CONSTRUCTION OF NEW MUNICIPAL SOFTBALL PARK REBID

PROJECT NO.: 08-18-C28-608

A D D E N D U M NO. 1

ADDENDUM No 1
SOFTBALL FIELD FACILITIES
MUNICIPAL PARK
McALLEN, TEXAS

L4.03

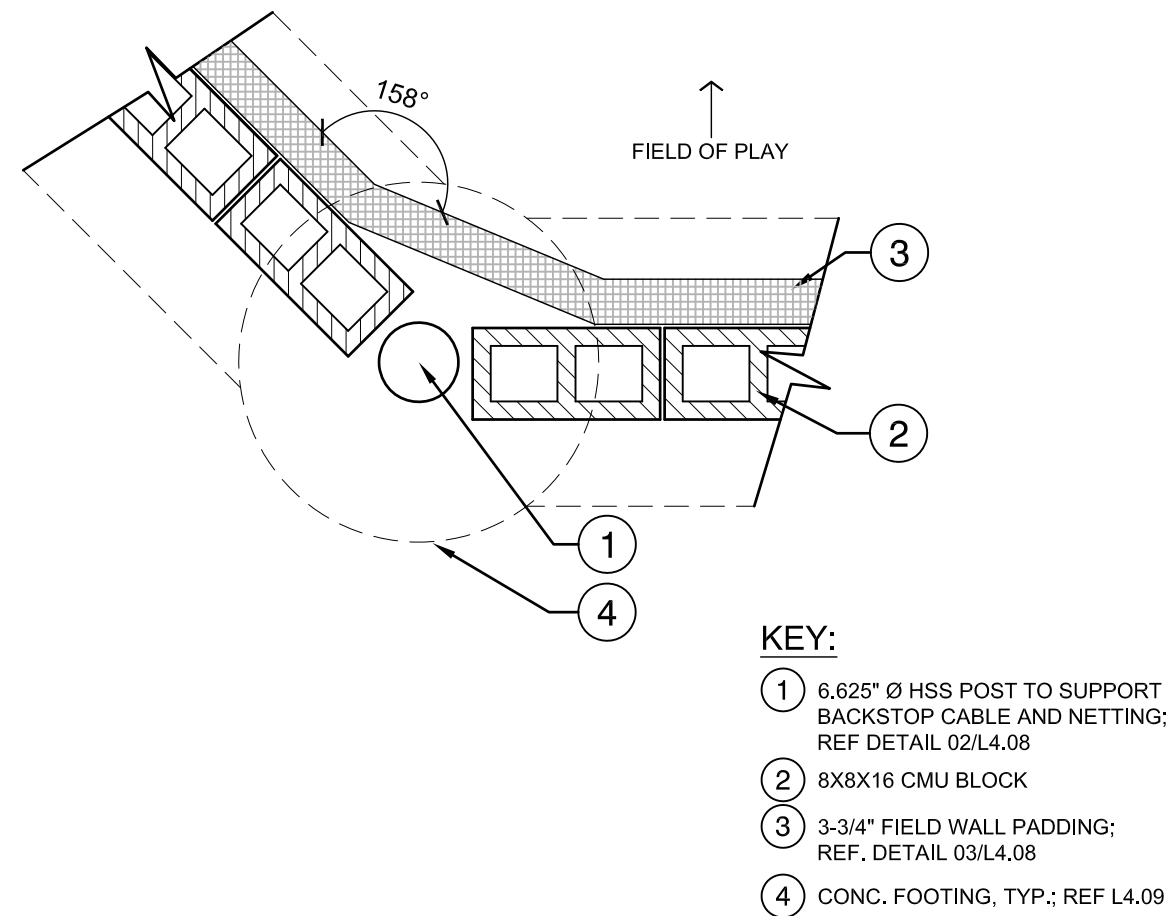
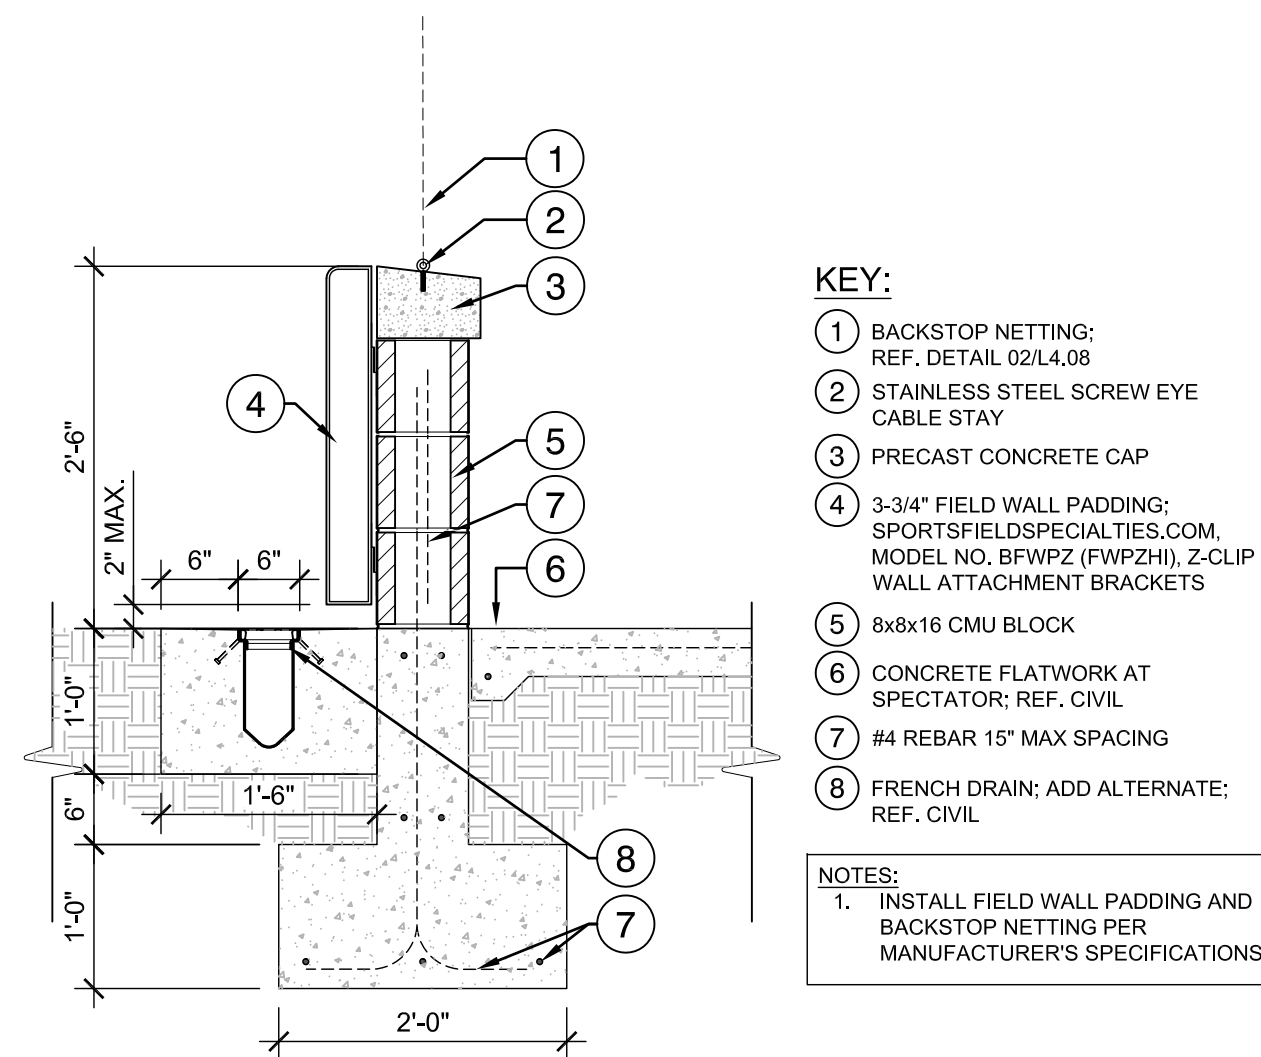
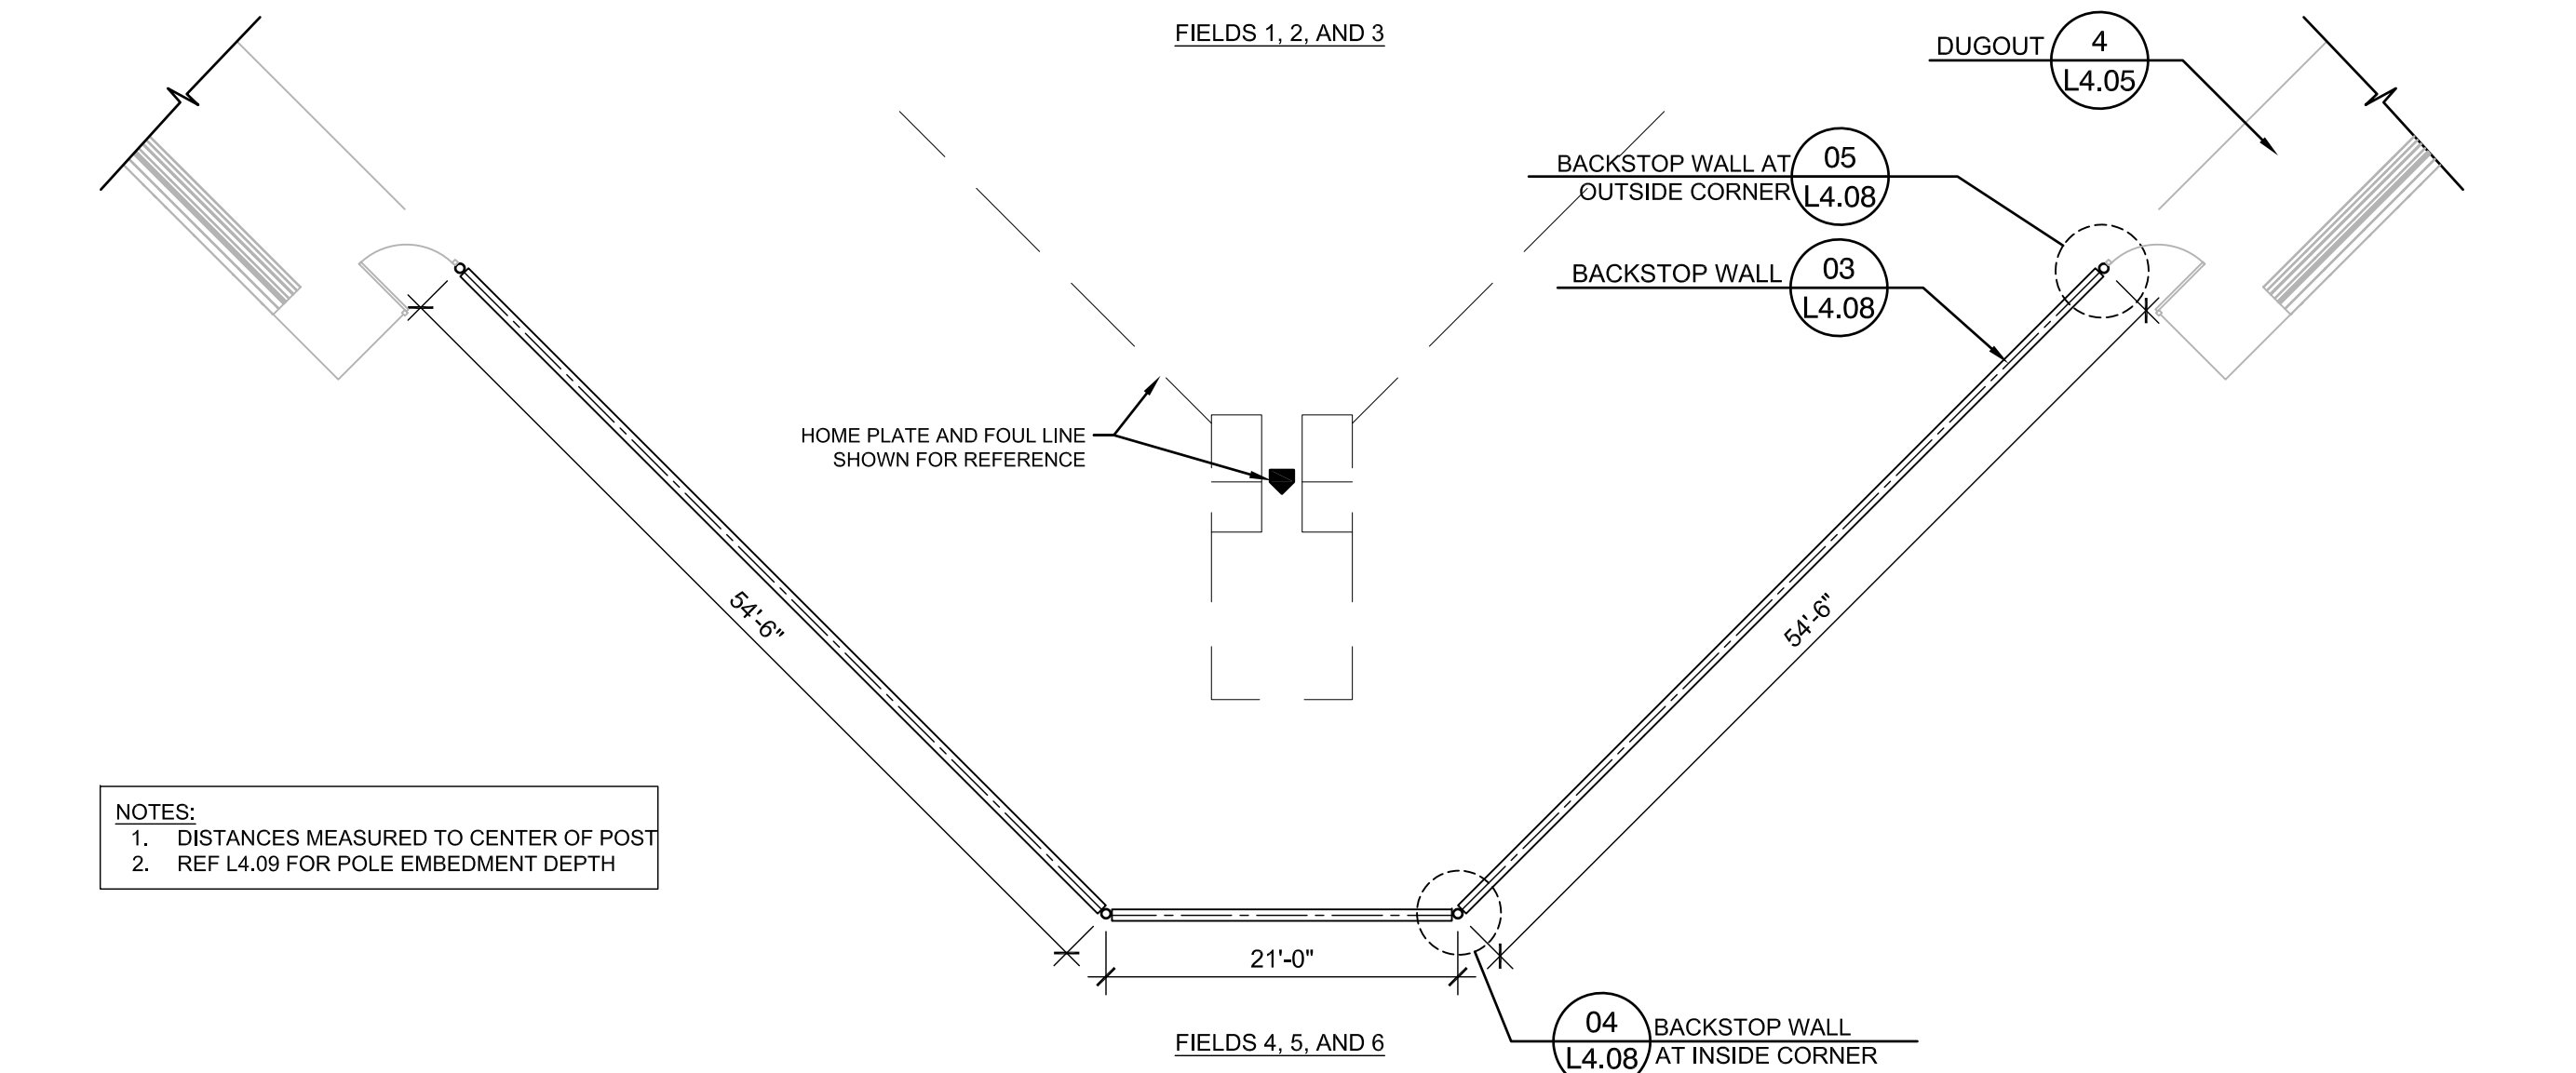
- L2.02 Modified sidewalk and dimensions leading to playground area.
- L3.02 Modified sidewalk leading to playground area.
- L4.03 Added note to indicate Net Backstop as Alternate No. 5.
- L4.04 Added note to indicate Net Backstop as Alternate No. 5.
- L4.07 Revised Details 1 and 2 to indicate chain link fabric to be 9 gauge steel .
- L4.08 NEW SHEET. Added sheet to include details for net backstop.
- L4.09 NEW SHEET. Added sheet to include detail for net backstop.
- L5.00 Revised Overall Plant Schedule to indicate new Grass Hydromulch quantity due to sidewalk modification.
- L5.02 Modified sidewalk leading to playground area. Revised Plant Schedule to indicate new Grass Hydromulch quantity due to sidewalk modification.
